DEVIATION REQUEST AND DECISION FORM

Low Flow Channel Bottom Width

Project Name : Sterling Ranch Sand Creek Channel Construction Drawing Review CDR 20-4
 Schedule No.(s) : 5227301021, 5233309027, 5228000030 & 38, 5233301001 5233301016 & 17
 Legal Description : See Exhibit B – Legal Description

Typical Channel Cross Section

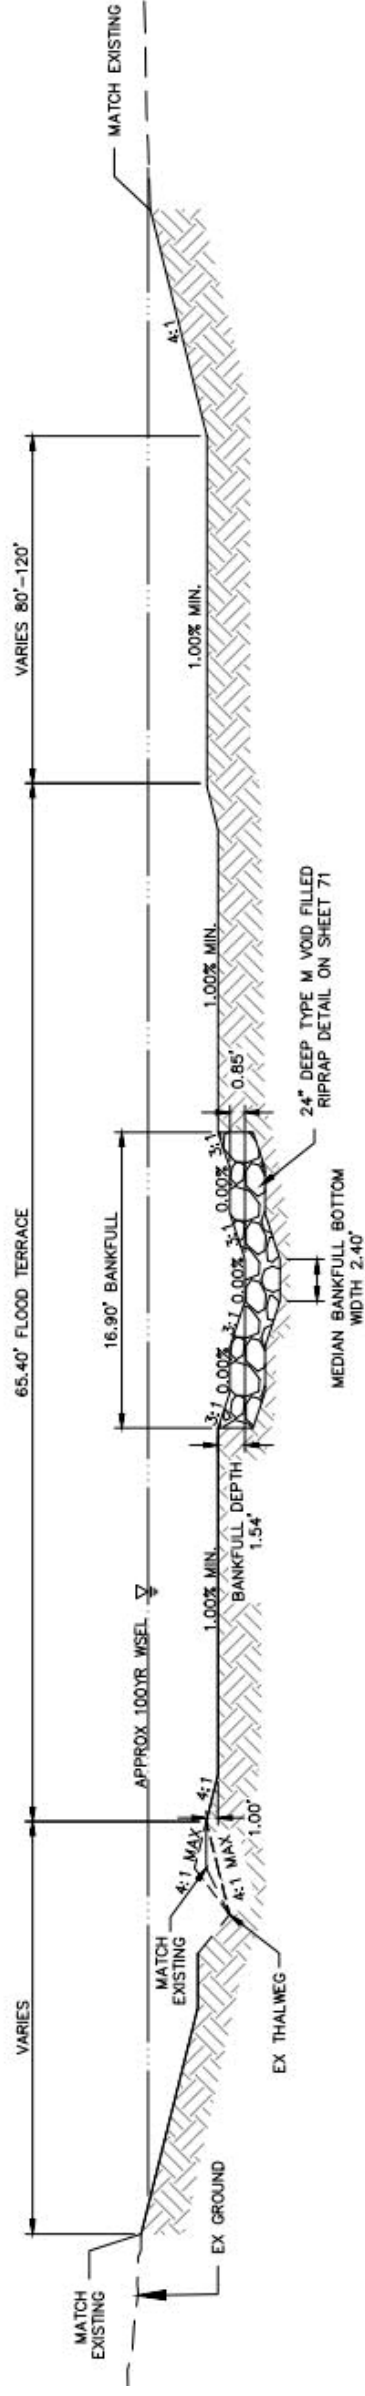
See Exhibit A for a representation of the "geomorphologist recommended" low flow channel cross section along with additional DCM 1 criteria excerpts.

The proposed low flow channel bottom width in the Sterling Ranch Sand Creek design is approximately 2.4 feet wide. The low flow channel is armored with 24" deep type M void filled rip rap.

The geomorphologist's reasoning for the smaller low flow channel cross section was that base flows in this reach of the channel are a fraction of the ECM criteria and a low flow channel sized to meet criteria would eventually cut its own low flow section for base flows. By using a narrower multi-stage section within the bankfull, dense vegetation can establish itself, particularly along the inner berm. This densely vegetated section should require minimal maintenance.

Maintenance of the low-flow channel shall be by the Sterling Ranch Metro District.
